Rezoning Transportation Analysis

Petition Number: 2022-210

General Location Identifier: 14506122, 14506121, 14506128, 14506120, 14606126

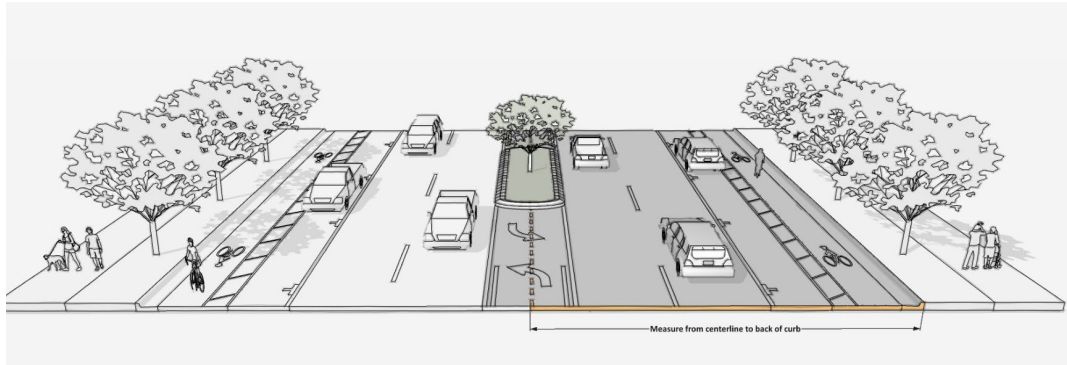
- a. ~~**South Tryon Street:** Location of curb and gutter to be moved a minimum of 42.5 feet from roadway centerline to accommodate the Charlotte Streets Map with a roadway typical section of a 4+ Avenue with Buffered/Separated Bike Lanes and On-Street Parking.~~

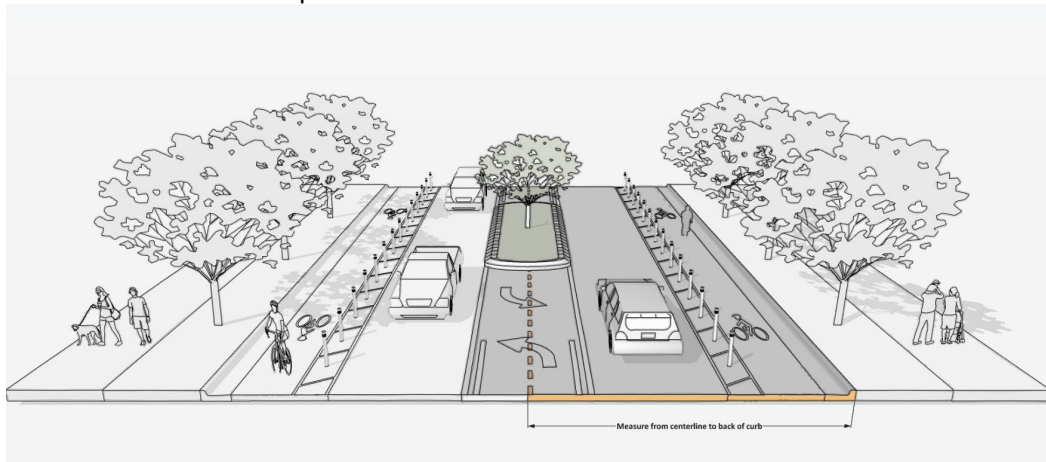
- b. ~~Clanton Road: Location of curb and gutter to be moved a minimum of 27 feet from roadway centerline to accommodate the Charlotte Streets Map with a roadway typical section of a 2+ Avenue with Buffered/Separated Bike Lanes.~~

NOTE: Additional distance from center line to back of curb may be required in locations where a median and turn lanes are required. Final curblines to be reviewed by CDOT once TIS is approved.

Outstanding Comment 9.20.23: Label and dimension the curb and gutter from the centerline for each road on the site plan.

Clarifying comment 6.21.23: Label and dimension the curb and gutter from the centerline for Clanton Road and South Tryon Street.
